Appendix D

SITE LANDSCAPE PLAN
PAPANUI PAK'N SAVE
 MAIN NORTH ROAD
 CHRISTCHURCH

From: Michelle Ruske <Michelle.Ruske@aurecongroup.com>
Sent: Monday, 8 July 2019 4:33 p.m.
To: Harris, Nathan
Subject: RMA/2018/2029 - Proposed Landscape Species Change

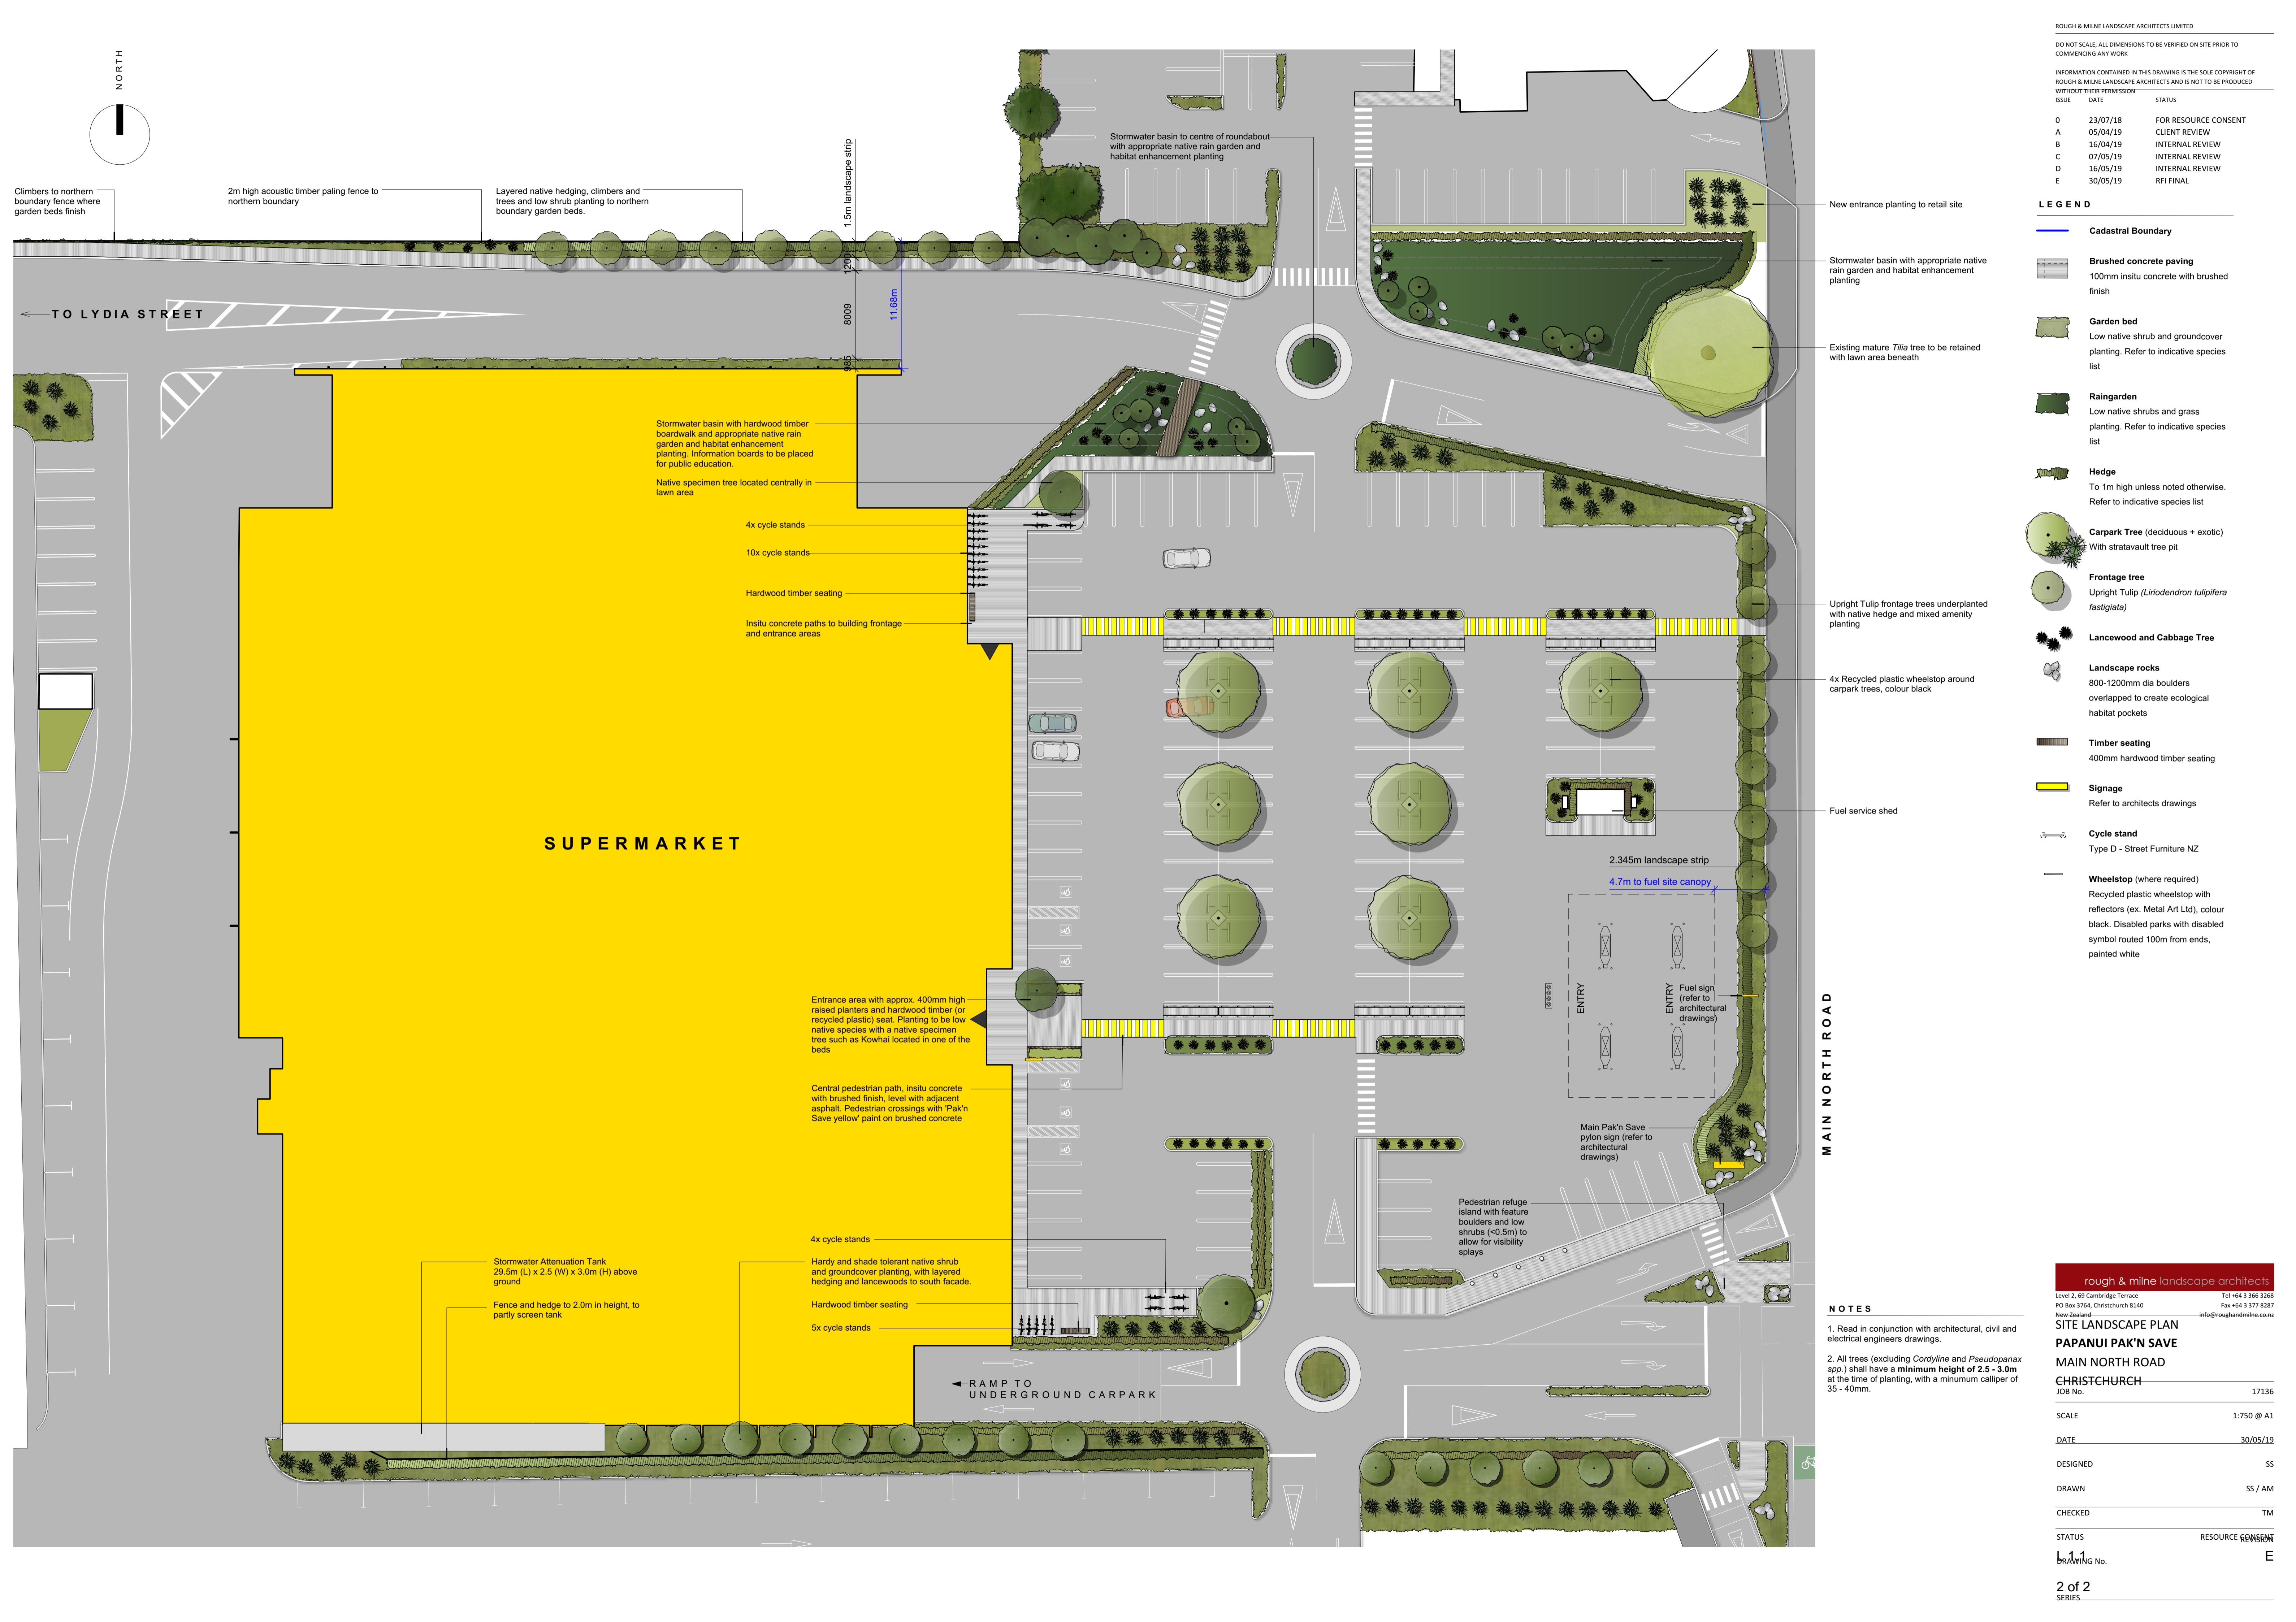
Following this correspondence, the applicant has adopted the recommendation from Mr Burrell that only locally-sourced native plants will be used on site. The proposed landscape species list enclosed in the Landscape and Urban Design Report (p. 23 of Appendix E) will apply with the exception of the following exotic species which no longer form part of the proposed landscape species list (*Alnus cordata*, *Platanus* 'Autumn Glory', Upright Tulip '*Linodendron tulipifera fastigiata*', *Lomandra* 'Tanika', *Penstemon* spp., *Rudbeckia* spp., and *Thymus* spp.).
